## 7. COA-057315-2019

617 West 21<sup>st</sup> Street

# Commission of Architectural Review

## STAFF REPORT

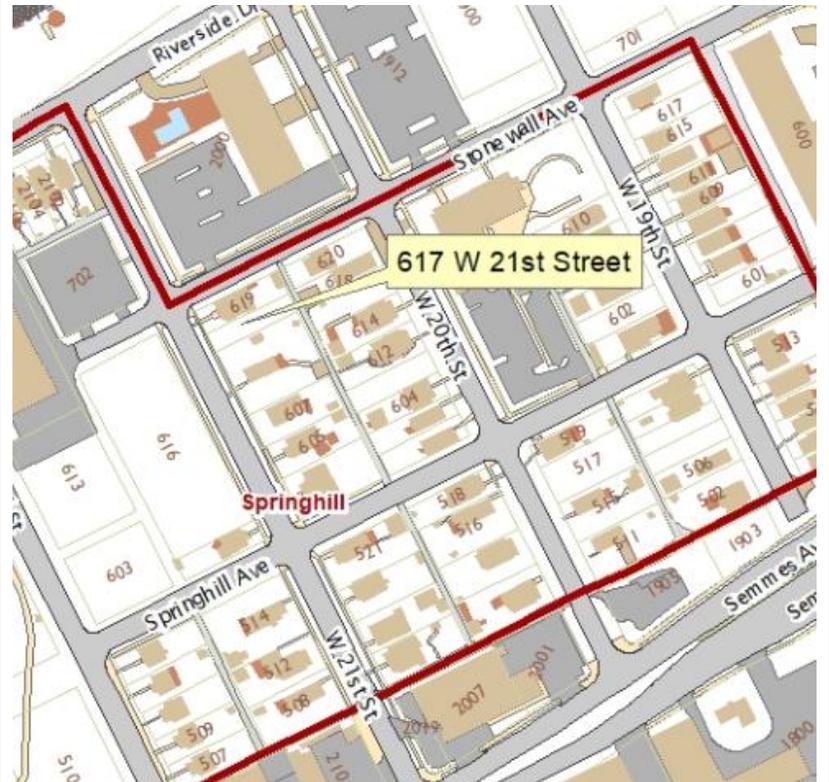
**Parge foundation, relocate HVAC units, construct a new shed, remove window casings, install rear doors, and add railing to rear patio.**

- The applicant proposes the following changes from the previously approved plans:
  - Parge the foundation instead of installing a brick veneer
  - Locate the HVAC units on the right side of the house instead of the left side as shown on the plans
  - To not install the window casing
  - Change the rear doors from a 15-lite door to a single lite.
  - Install a deck with railing at the rear of the building instead of a concrete patio
- The applicant also requests permission to install a small shed in the rear yard.

## APPROVE WITH CONDITIONS
